Responses to NRC Questions  
on the Enrico Fermi Atomic Power Plant  
Unit 2 Plant Unique Analysis Report

Detroit Edison Company

NUTECH Engineers, Inc.  
San Jose, California

TORUS SHELL PRESSURES DUE TO POOL SWELL AT KEYTIMES AND SELECTED LOCATIONSKey Diagram

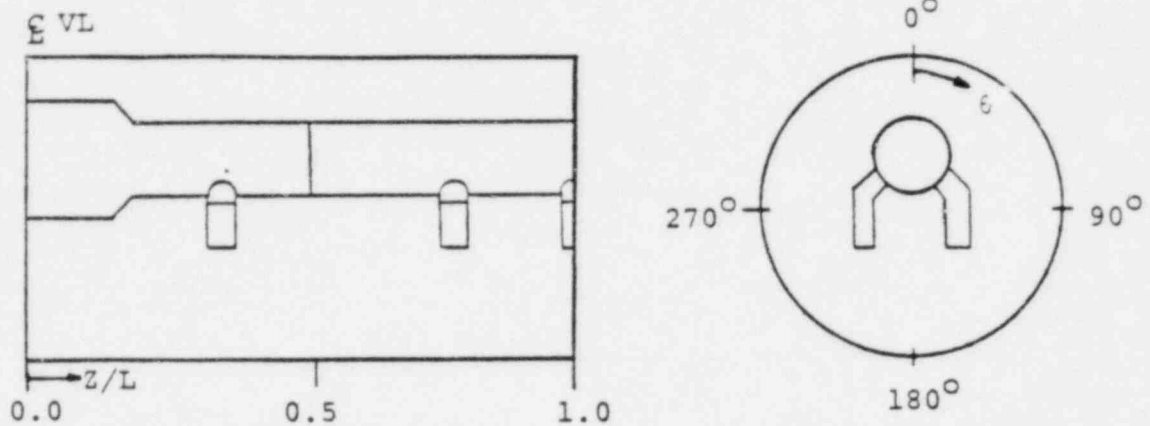
PUAR Section 2.2.2.1 (Page 2.2-30), AC Section 2.3 and 2.4. Additional information is required concerning the torus shell pressures presented in Table 2-2.2-3 on page 2-2.48 of the PUAR. Provide the details of a specific torus shell pressure calculation at the two times specified in the table for a typical longitudinal location as a function of circumferential location (e.g.,  $Z/\lambda = 0$ ,  $\theta = 180, 150, 120$ , and  $90$  degrees). The following information should be included as part of the response with and without the margins imposed by NUREG-0661.

- (a) Net torus vertical load history.
- (b) Average submerged pressure history.
- (c) Torus airspace pressure history.

Illustrate how these pressure histories are used in conjunction with the Load Definition Report (LDR) multipliers to arrive at the values presented in the table.

The attached Table 13-1 provides additional information to clarify PUAR Table 2-2.2-3. Table 13-1 shows the torus shell pressure values used in the Fermi 2 structural analysis which were calculated in accordance with NUREG-0661 requirements. The bases for the values in Table 13-1 and PUAR Table 2-2.2-3 are described in the following paragraphs.

Table 13-1 shows torus shell pressure components which include all the NUREG-0661 margins. Table 13-1 also shows locations at which the LDR longitudinal multipliers were obtained and the range over which each multiplier was applied. A description of how the values in Table 13-1 were obtained is provided in the following paragraphs.

Table 13-1 provides additional information to clarify PUAR Table 2-2.2-3 and shows the net pressures used in the structural analysis which includes the margins imposed by NUREG-0661.
